# **ADDENDUM NUMBER 5**

<u>Bid No. F13-04 COMMUNITY DAY SCHOOL</u>
<u>For</u>
SAN BERNARDINO CITY UNIFIED SCHOOL DISTRICT

February 28, 2014

## TRASH / ELECTRICAL ENCLOSURE - NEW WORK PLAN

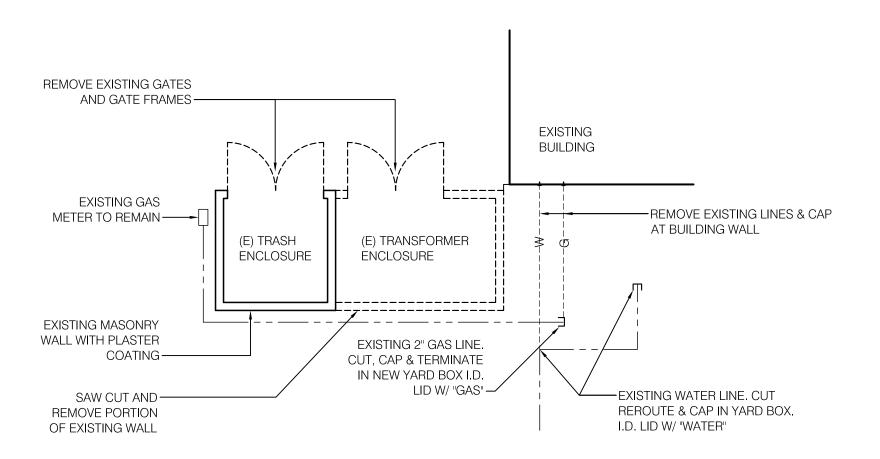
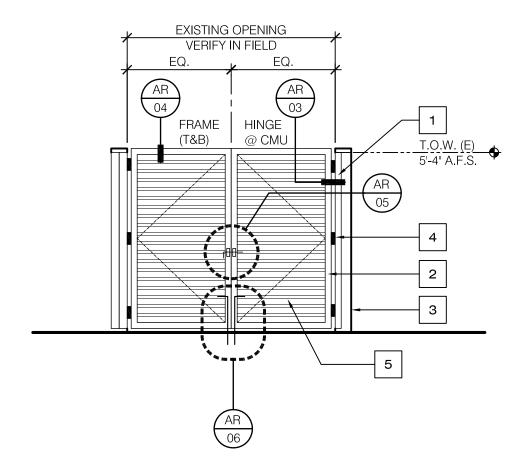
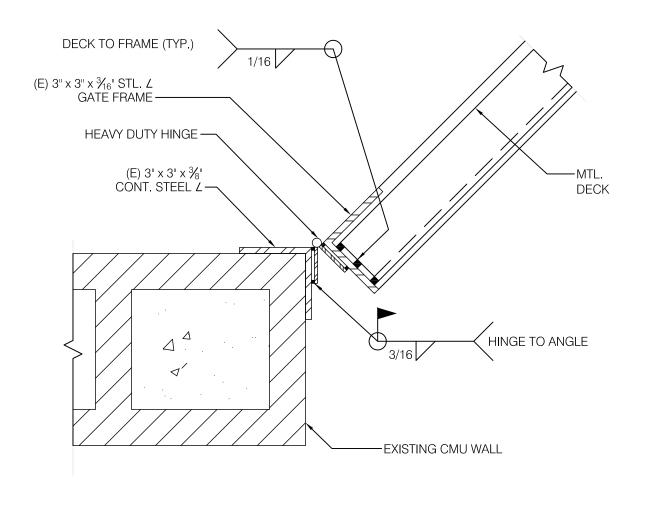
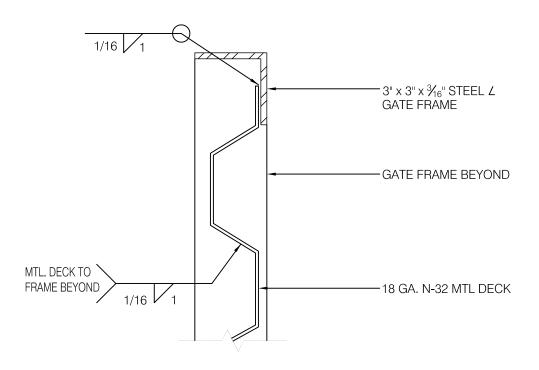
**Item Number 5**; Reference Sheet A3, Electrical Enclosure adjacent to Building C; Revise the enclosure per attached drawings **AR-01**, **AR-02**, **AR-03**, **AR-04**, **AR-05** and **AR-06**.

- 1. 5" x 3" x 3/8" STL. ANGLE HINGE SUPPORT PAINTED, TYP.
- 2. 3" x 3" x  $\frac{3}{16}$ " STEEL GATE FRAME, PAINTED TYPICAL.
- 3. (E) 8" x 8" x 16" CMU WALL WITH PLASTER FINISH
- 4. (3)  $2\frac{1}{2}$ " x  $2\frac{1}{2}$ " x  $2\frac{1}{6}$ " STEEL WELD ON HEAVY-DUTY, 5 KNUCKLE HINGES W/ NON-REMOVABLE PINS, EACH LEAF.
- 5. 18 GA. 3" MTL. DECK PRE-PRIMED, ASC N-32 OR EQUAL. PAINTED TYP.

ROOF CLOSURE @ MATCHING ROOFS

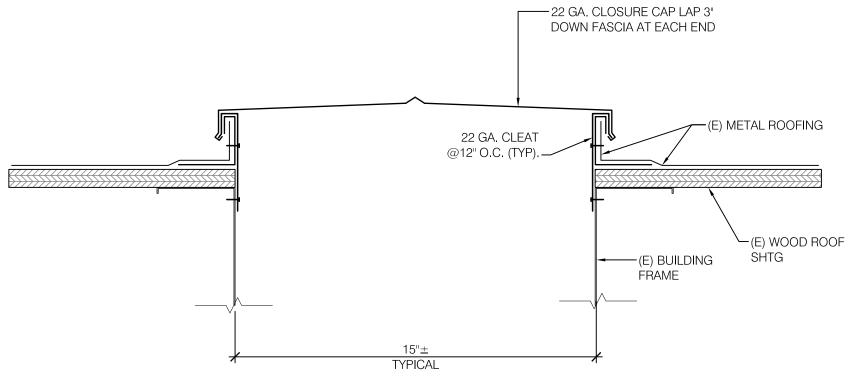
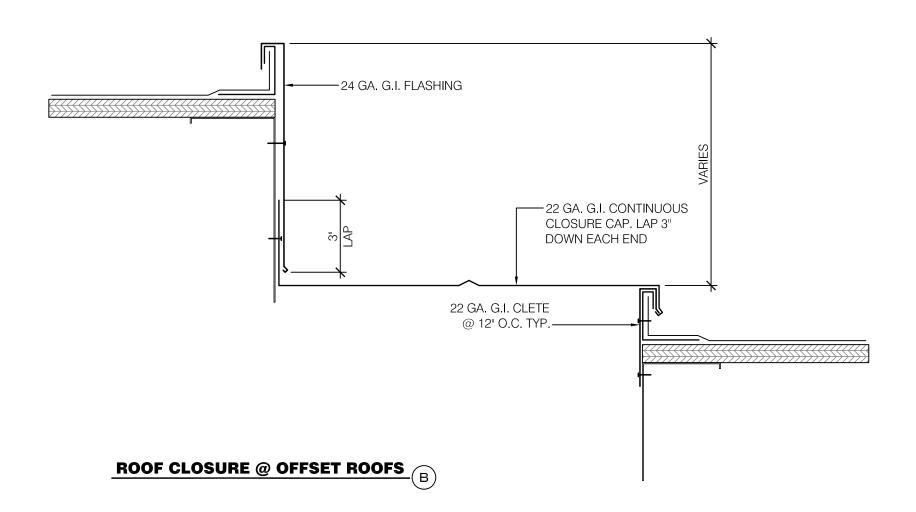
**Item Number 6;** Reference Sheet A5- Admin Building; Provide roof closure flashings per attached drawing **AR-07**

ESK-2

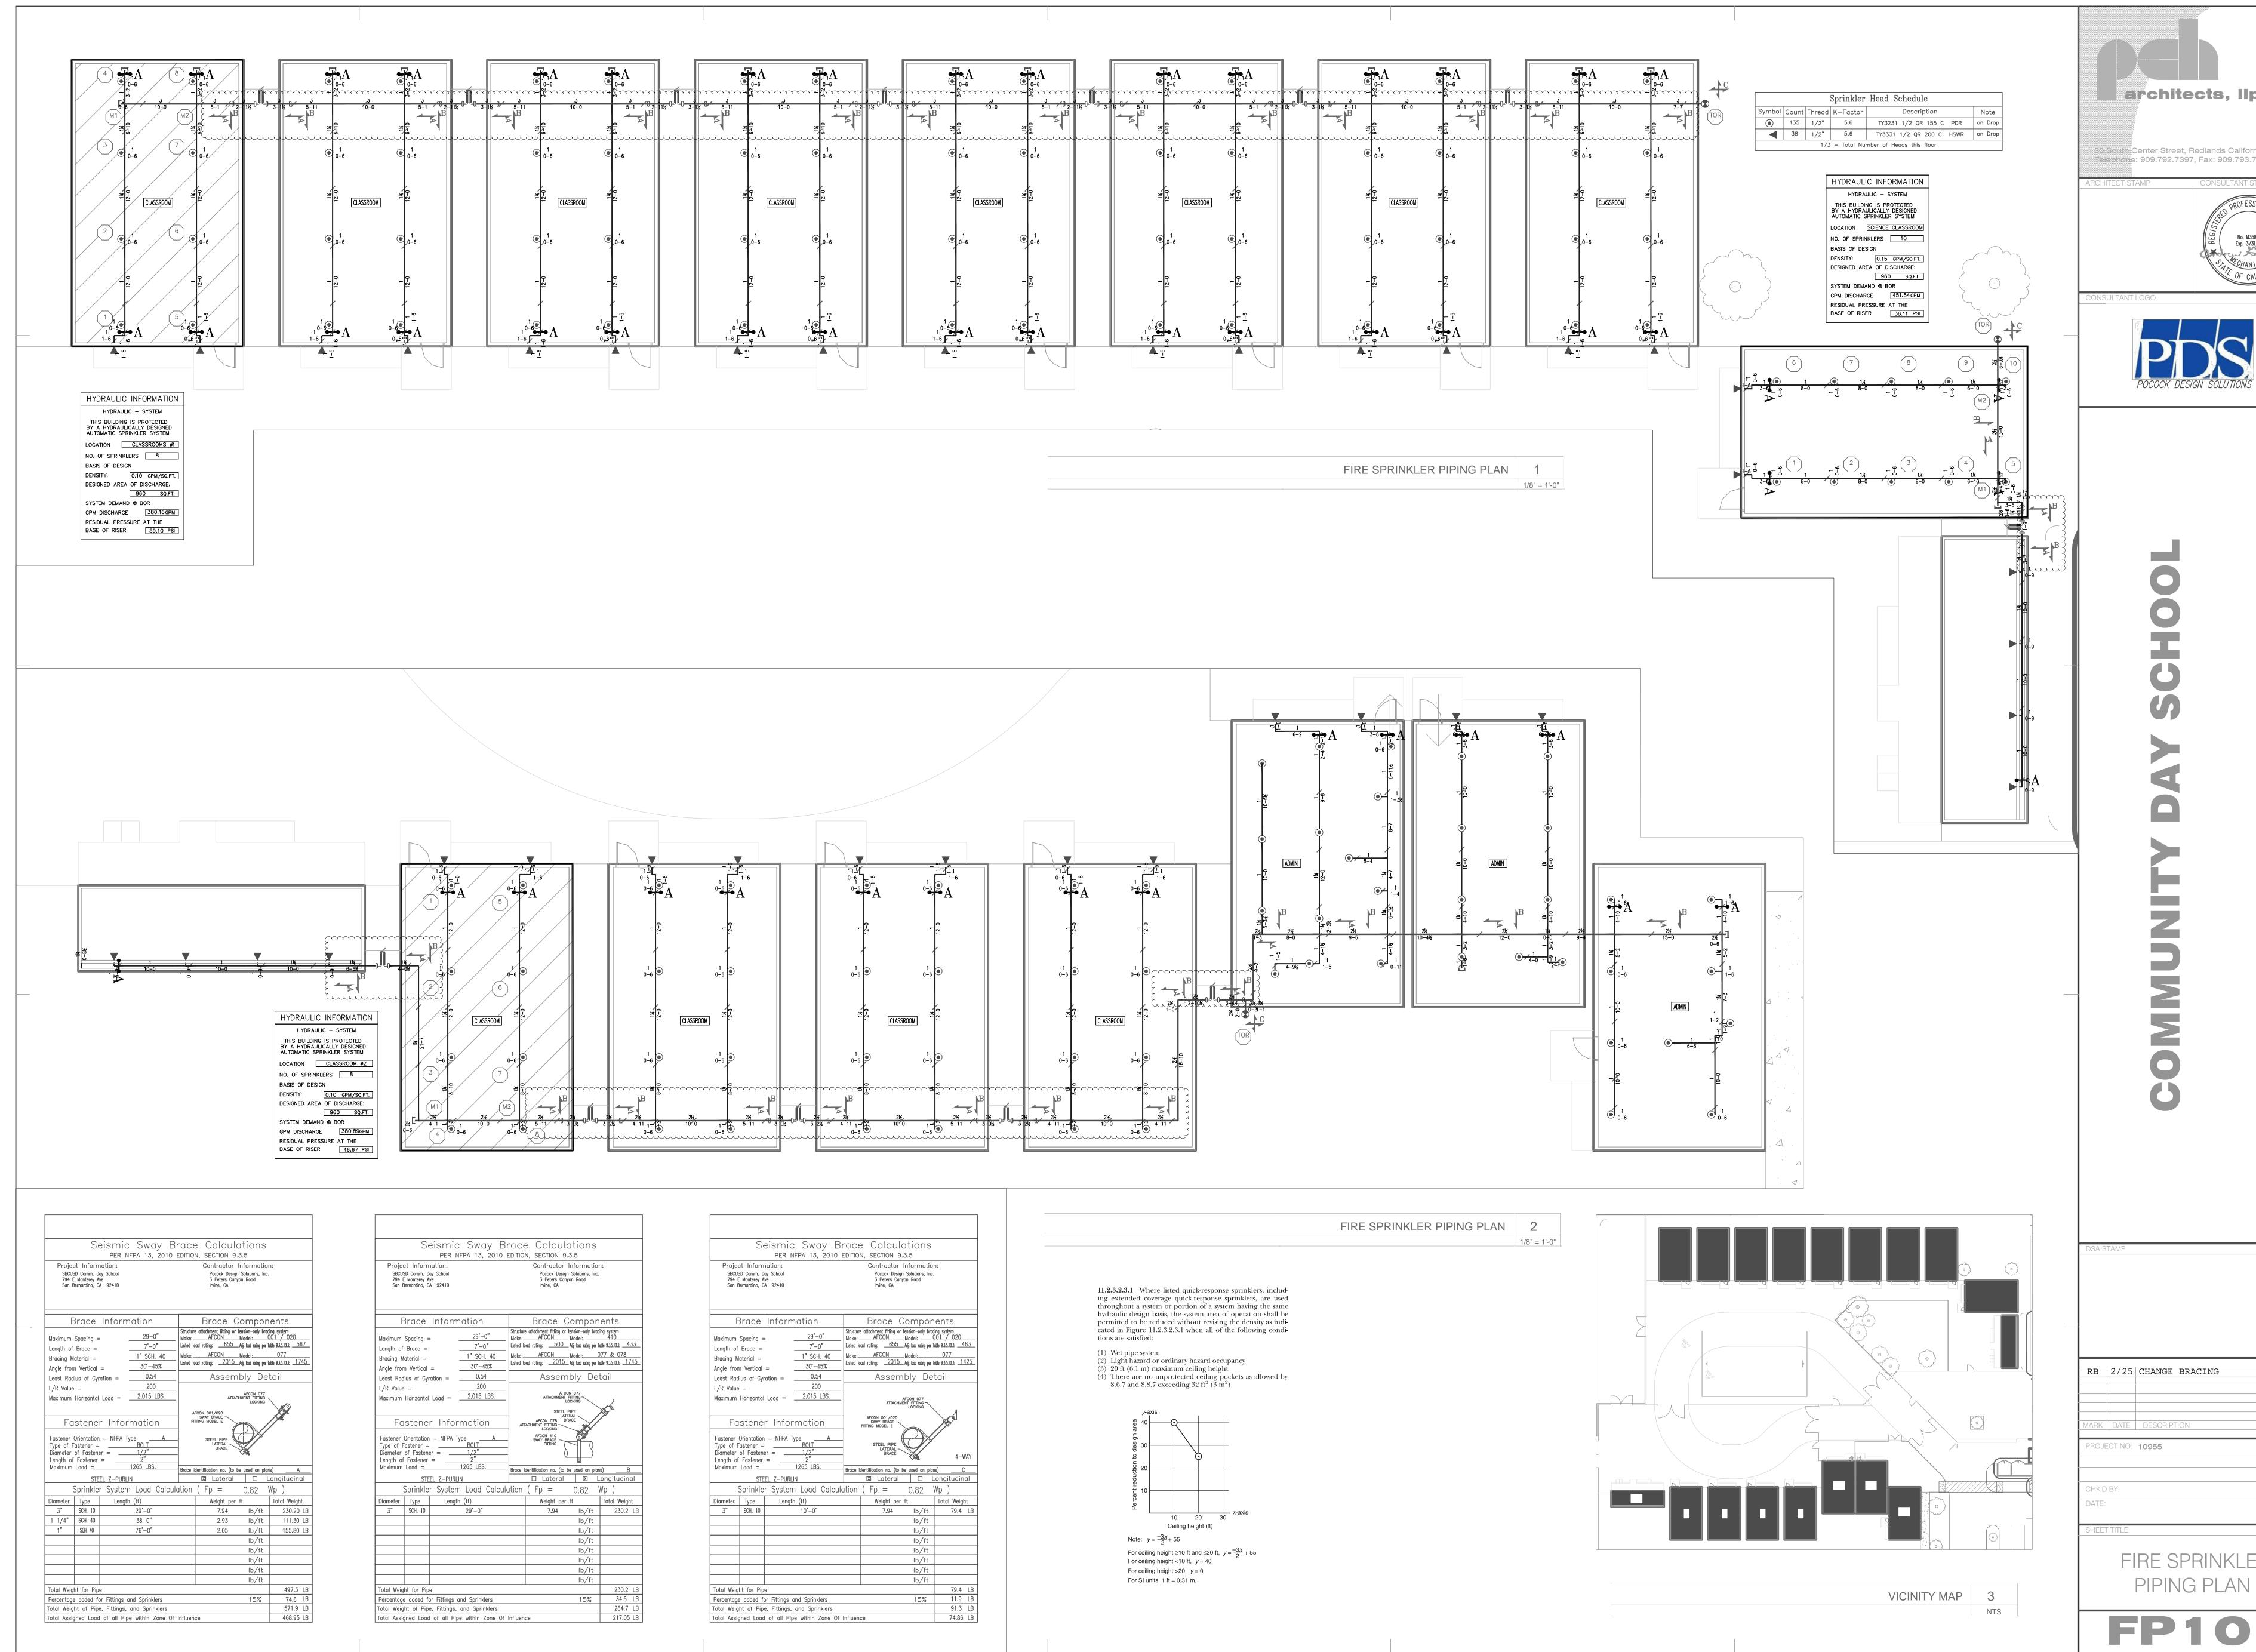
- Add a 2'X3' Concrete pull box for DPR2-1 through 4 feeders and locate behind relo B5.
- Revised New Utility enclosure per attached ESK-2 drawing.
